Annex D

**Replacement Pages of Air Ventilation
Assessment**

Project Title
PROPOSED COMMERCIAL DEVELOPMENT ON IL NO.8945 AT CAROLINE HILL ROAD, CAUSEWAY BAY, HONG KONG

Drawing Title	
SECOND FLOOR PLAN	
Project No.	21105HK
Scale	1:750 (A3)
Issue Date	Jan 2024
Drawing No.	MLP-008

Figure 62 Amended Elevated Void on 2/F of T3

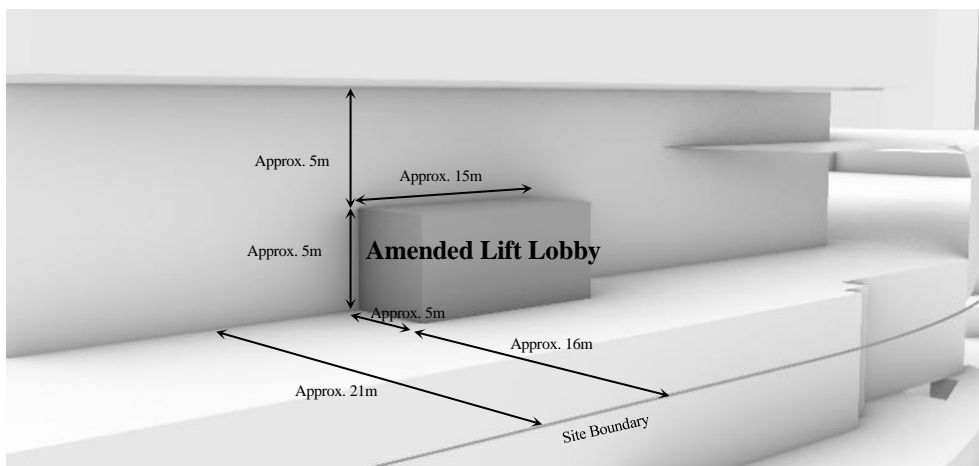
As the design continue to develop, the lift lobby on 2/F of T3 is enlarged to allow more room for pedestrian flow. This result in an amendment to the elevated design on 2/F of T3 including an extension of lift lobby towards the elevated void with approx. 5m (W) x 5m (H) x 15m (L). The amended elevated void varies from approx. 21m widest to 16m narrowest with a height maintained with approx. 10m. An additional void with approx. 5m (W) x 5m (H) is located above the amended lift lobby. An illustration diagram is shown in Figure 62.

For incoming wind from eastern side, the amended lift lobby is a minor extension from core structure and away from the north-eastern site boundary, which minimize the blockage. The elevated design with at least 16m (W) x 10m (H) are free of obstruction for eastern wind. With additional 5m(W) x 5m (H) void atop the lift lobby, the effectiveness of the void would be insignificantly affected. Wind from eastern side would still be able to flow through underneath the tower. Some localized impact may be observed at the landscape deck under T3 within the Site, the influence on Caroline Hill Road would be minimal.

For incoming wind from south-western direction, the elongated shape of core structure would dominate the wind environment and cast a localized wind shadow at the elevated area under T3. The amended lift lobby would fall within shadow zone and the influence from the amendment on ventilation performance would be insignificant.

In summary, the amendment would impose insignificant ventilation impact to wind performance along the site boundary and assessment area, the simulation discussed in previous sections remained valid after the amendment.
